Willa
889537

From David Makepeace, March 17, 2004.

Here are my suggestions on Willa/LH drilling.

From: Schroeter, Tom EM:EX
Sent: Tuesday, April 13, 2004 8:25 AM
To: XT:Chapman, John Leader Mining International Inc EAO:IN
Subject: RE: long exploration holes planned for Willa/LH boundary

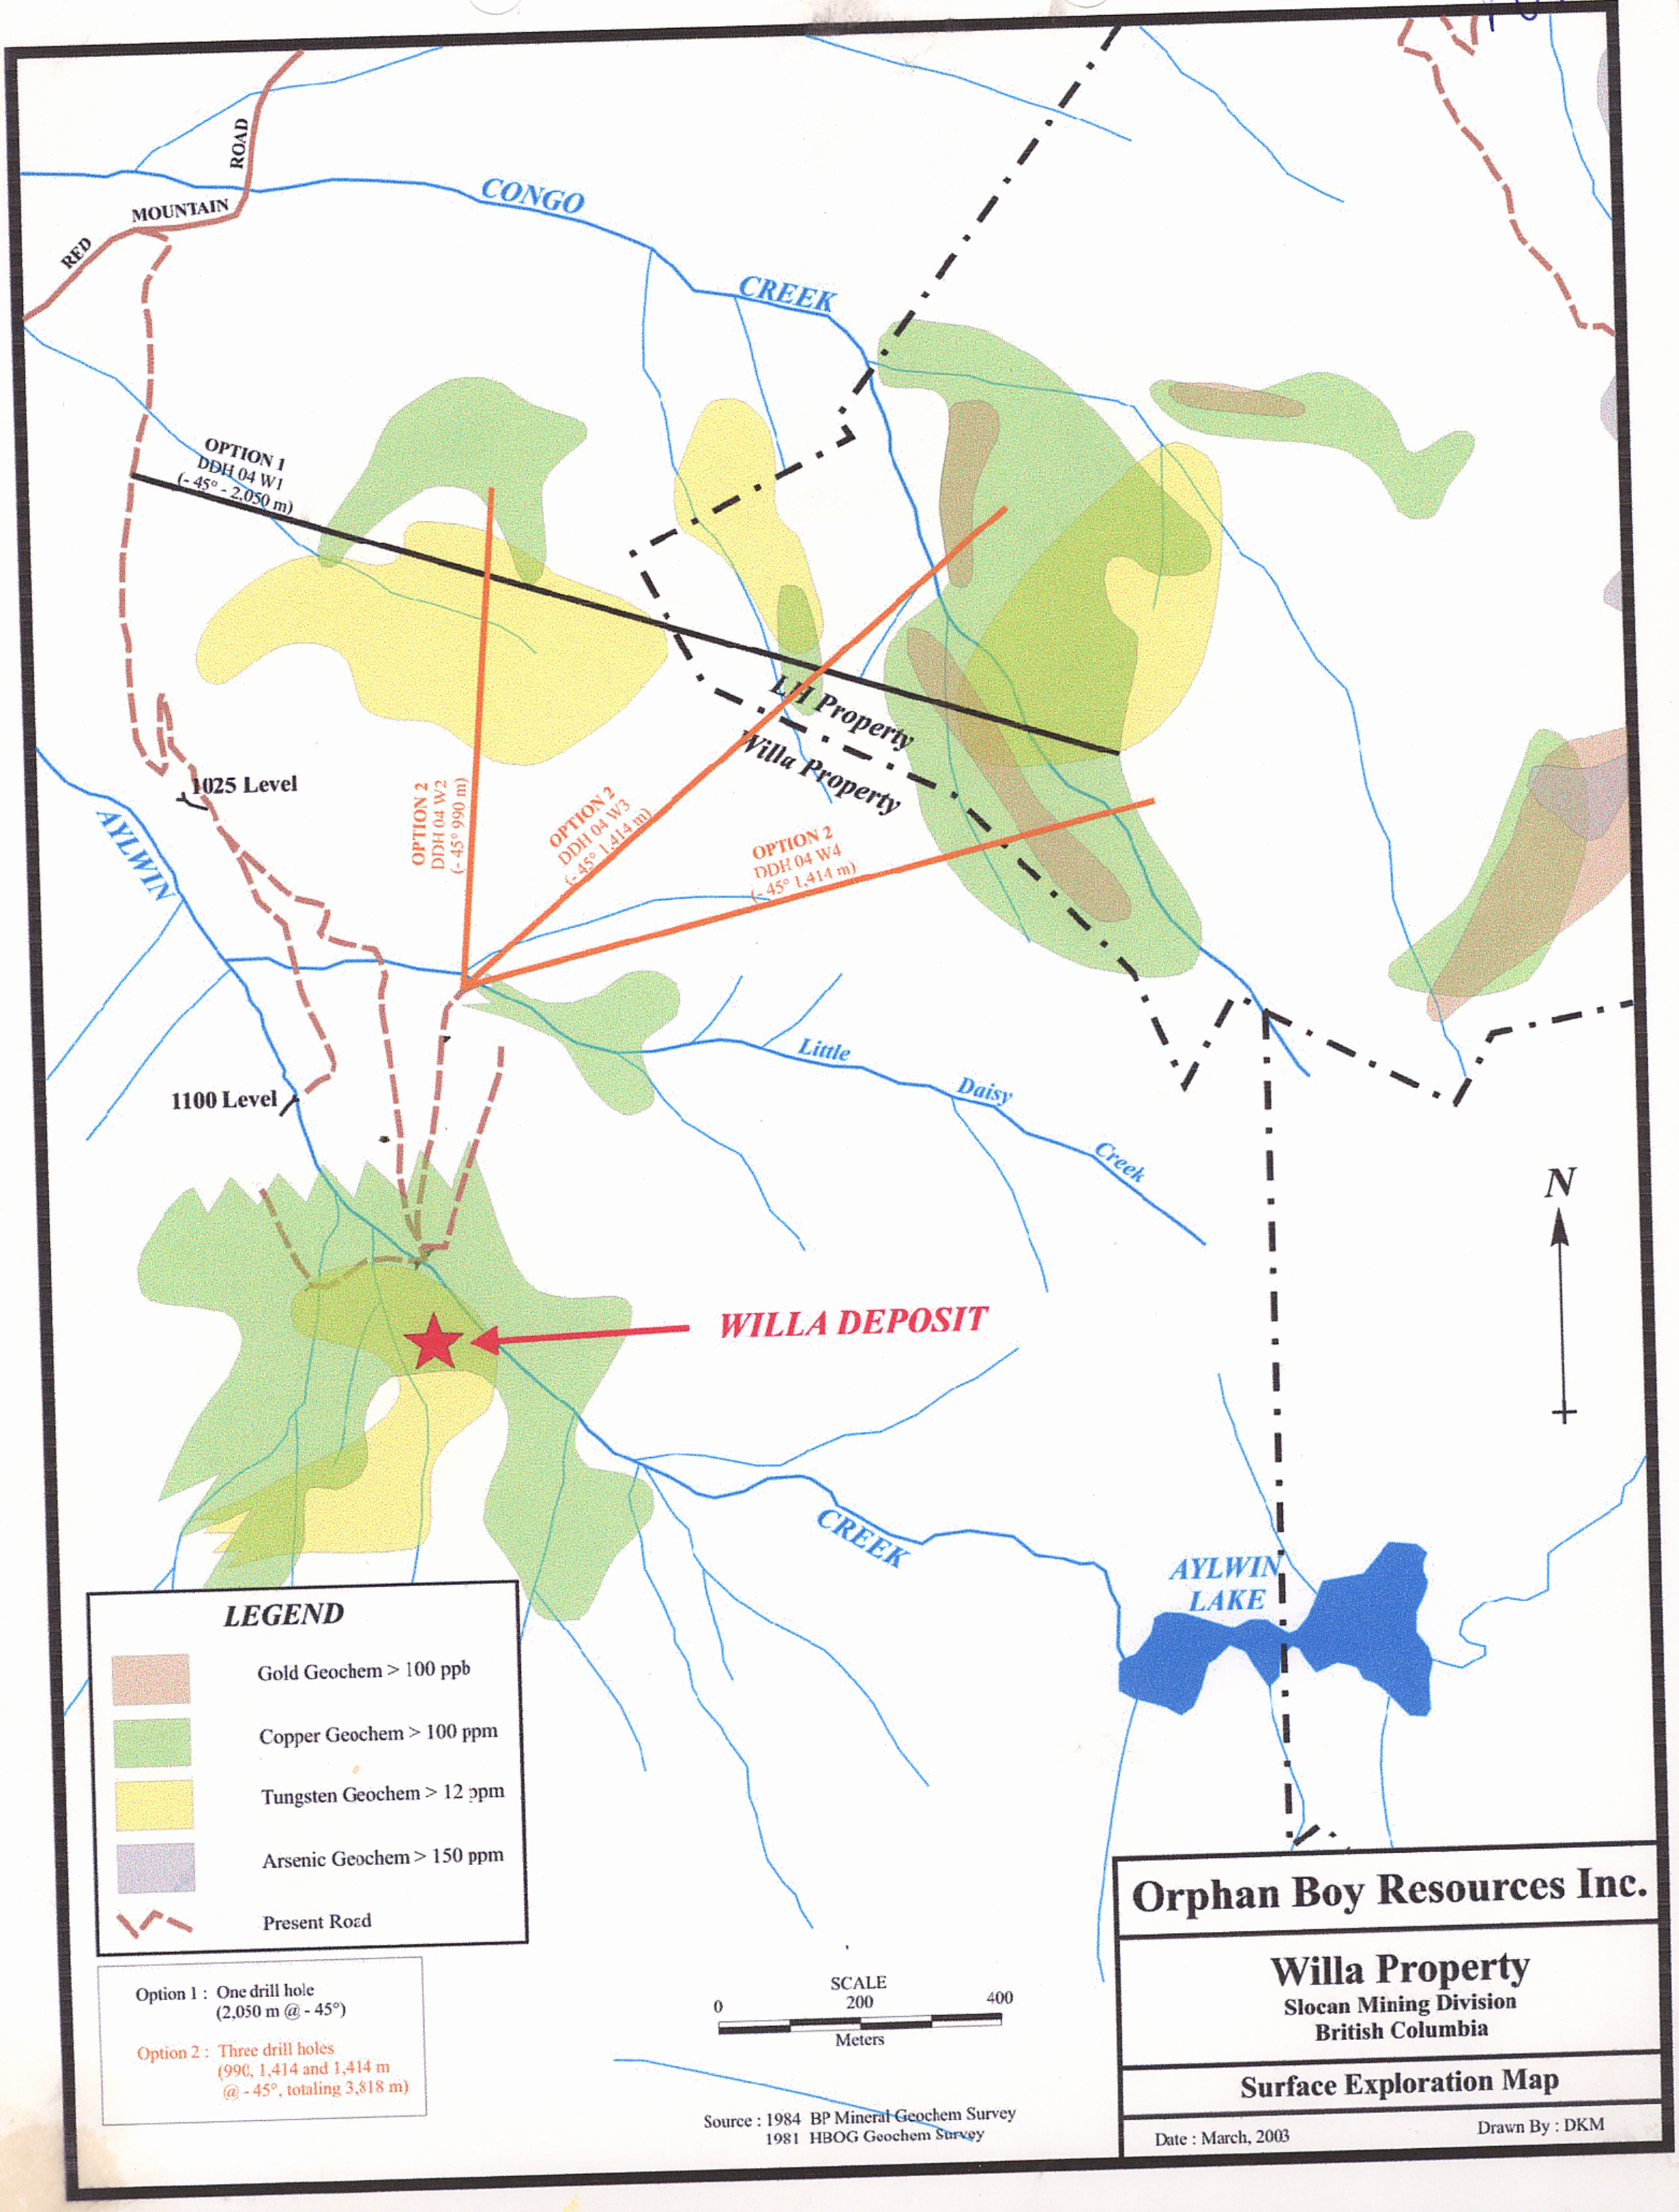
Option One:
- One deep hole that could cut all anomalies and be drilled from the present access road to the 1025 adit at -45° (2,050 m).

Pros:
- Cuts all anomalies with one hole and hence could find several mineralized zones.
- If there is deep mineralization you could find it.

Cons:
- Long hole and one chance to intersect any mineralization
- Mineralization would be below 1025 Adit
- Drill may block traffic to portal for a long time.

Option Two:
- Three fanned shorter holes at -45° off the end of the Little Daisy Adit access road (total 3,818 m).

Pros:
- Higher elevation so mineralization could be mined from 1025 level workings
- Closer to the source of the soil anomalies so possibly higher chance of intersecting mineralization
- 3 holes versus 1 hole so higher chance of intersecting mineralization
- It would not block traffic to 1025 level portal
- Road access already established
- Road access could also be used to undertake additional drilling to improve the near surface Main Zone mineralization

Cons:
- Road would have to be cleared of debris and washout at lower Little Daisy Creek crossing fixed
- If Little Daisy Creek is a fault, all the three drill holes would have to go through bad ground
- More drilling and hence more exploration costs.

I have spent too much time on thinking everything through so I'm sure my pros and cons list for both options would grow. It gives you something to think about. If it was up to me, I would choose Option 2
